CITY OF VANCOUVER  
COMMUNITY SERVICES GROUP

DEVELOPMENT PERMIT STAFF COMMITTEE REPORT  
JUNE 4, 2014

235 KINGSWAY (COMPLETE APPLICATION)  
DE417686 - ZONE C-3A

P2 PARKING PLAN  
 -  
 A2.0

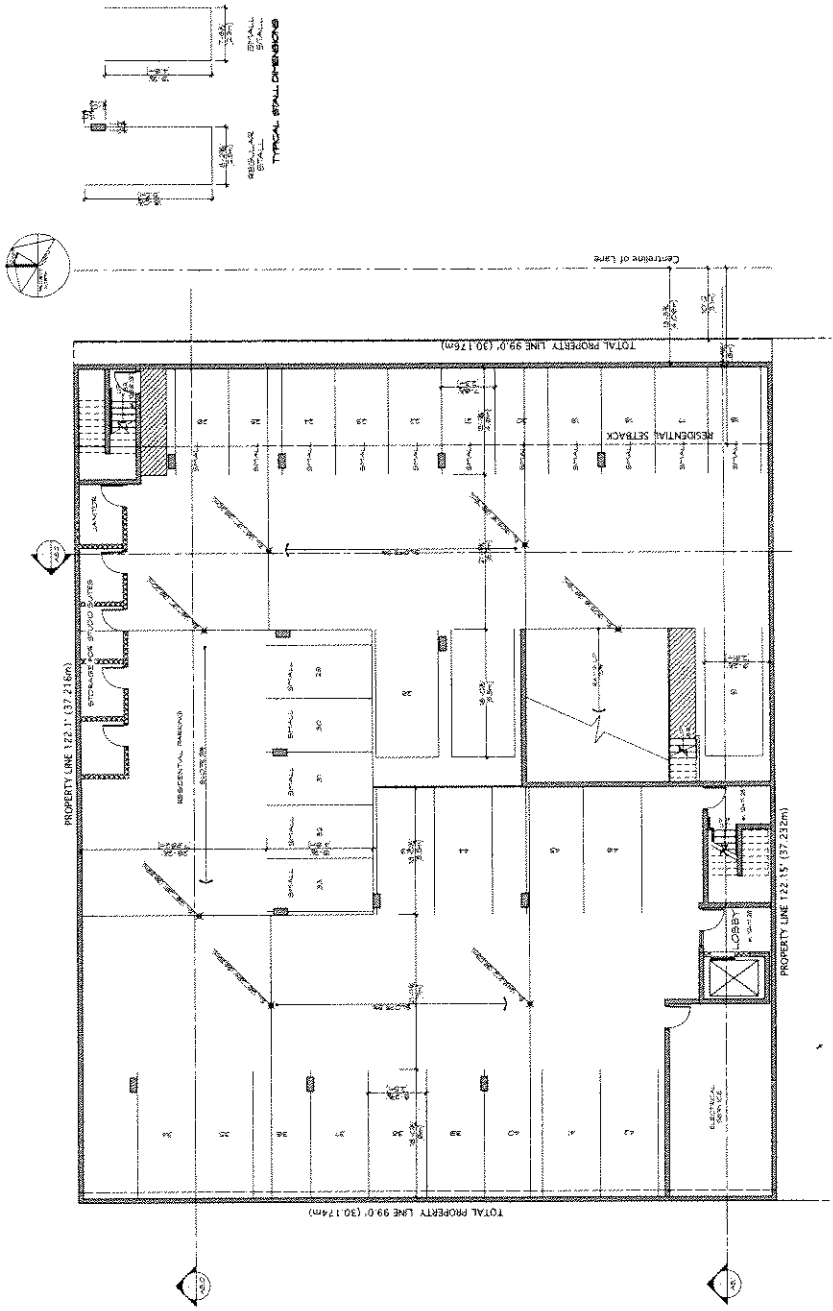
- a) Provision of a minimum 20 ft. (6.1 m) maneuvering aisle for stalls 29-33 on P2 as 19.5 ft. is shown on drawing A2.0;
  - b) Provision of a 0.6 m (2 ft.) setback for the 2 ft. long parking columns from the end of the stall to improve maneuvering;
  - c) Improve the alignment of the overhead gates and the maneuvering aisle on P1 to reduce or eliminate the shift of the maneuvering aisle between the commercial and residential parking;
  - d) Provision of 20 ft. (6.1 m) wide overhead gates for 2-way vehicle flow (18 ft. gates are shown on drawing A2.1);
  - e) Provision of an improved plan showing the design elevations on both sides of the ramp at all breakpoints and within the parking and loading areas to be able to calculate slopes and cross falls. Provide elevations and slopes on sections drawings;
-

**P1 PARKING PLAN**

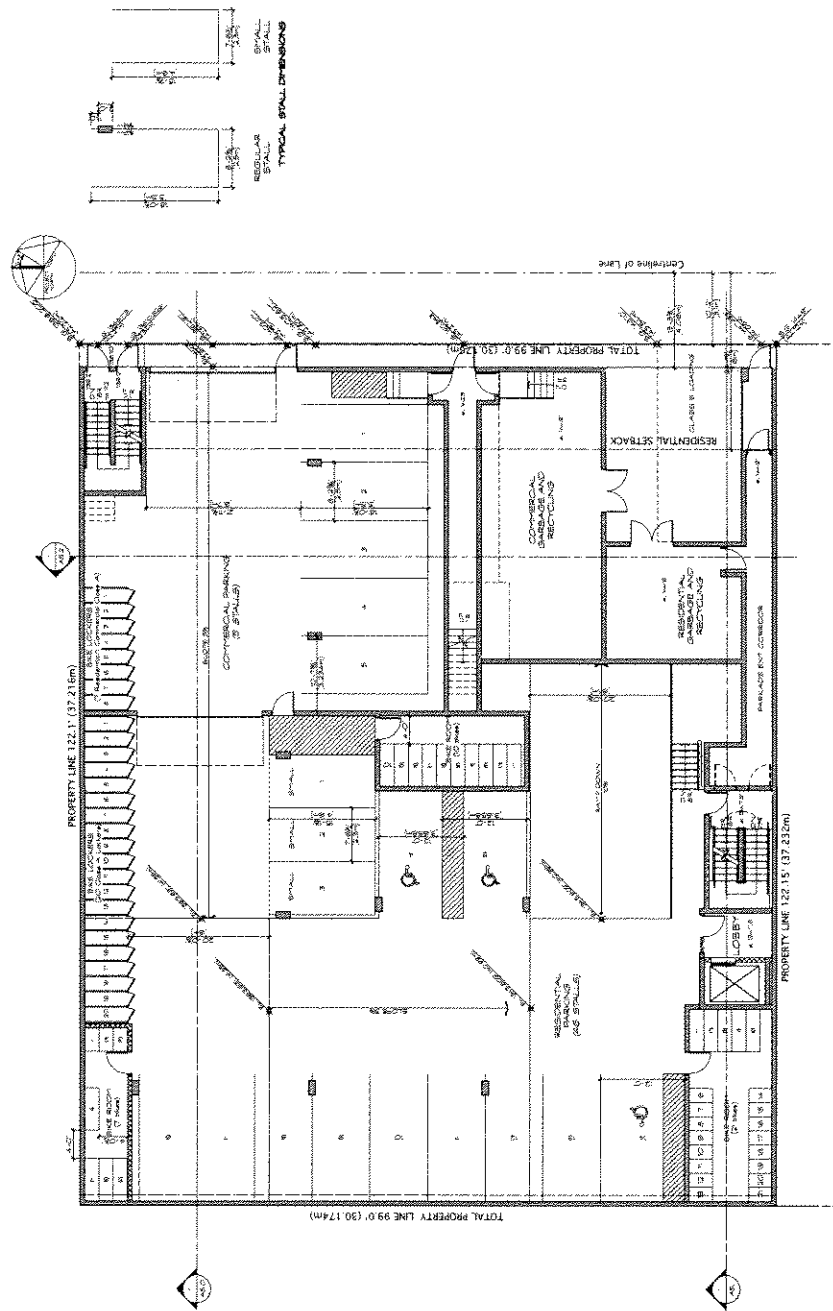
**Note to Applicant:** Provide correct imperial conversion of the metric design elevation 42.64 m at centre line of parking ramp (see P1 parking plan) and;

**WEST (KINGSWAY) ELEVATION**  
 SCALE 1/8" = 1'-0"

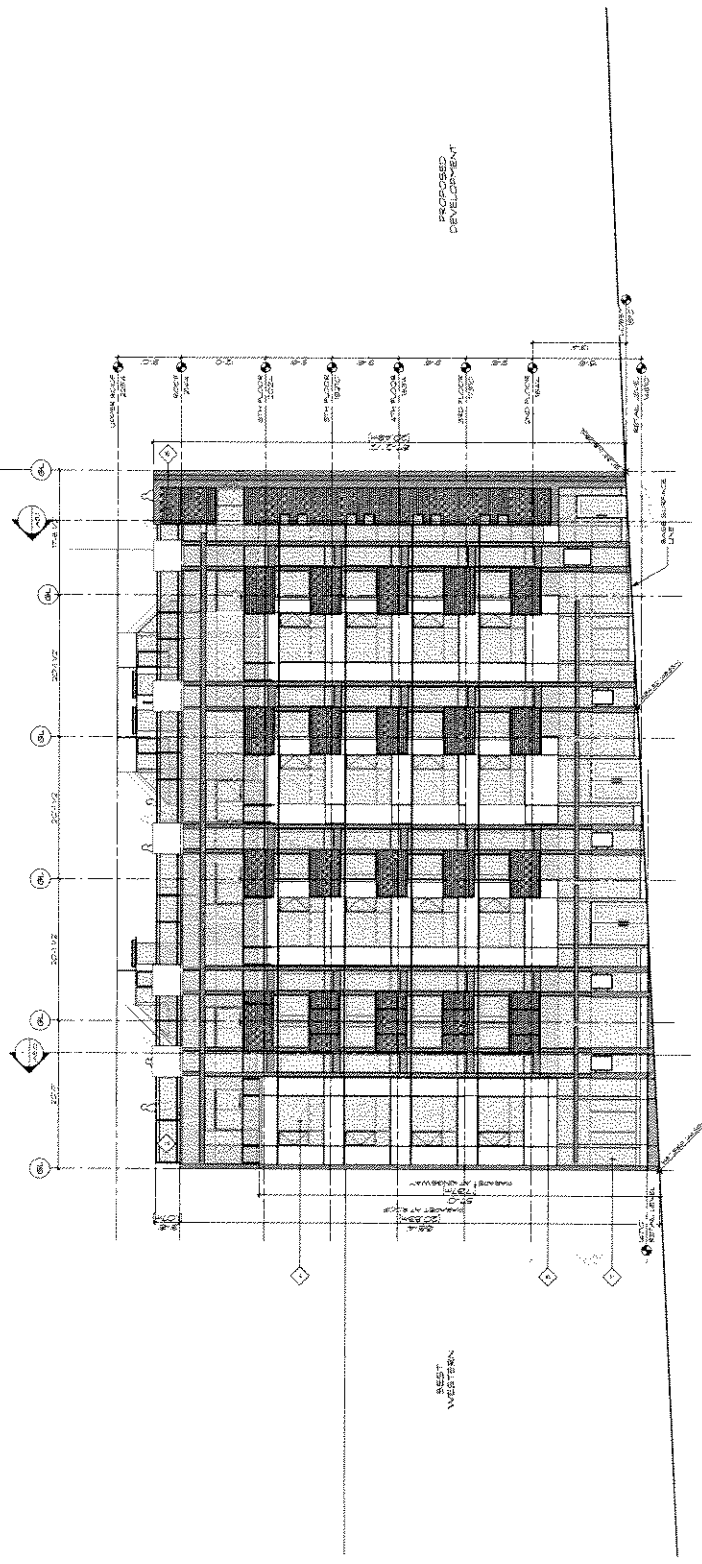
- 1.3 design development of the west elevation (Kingsway) to provide improved articulation, depth and relief of the enclosed balconies to help reduce the mass and visual scale of the building.

**Note to Applicant:** In general the depth of the elevation appears to be shallow which contributes to the overall bulk of the building. Provide a minimum offset dimension of 0.9 m (3 feet) between the enclosed balconies and the line of glazing of the living rooms.
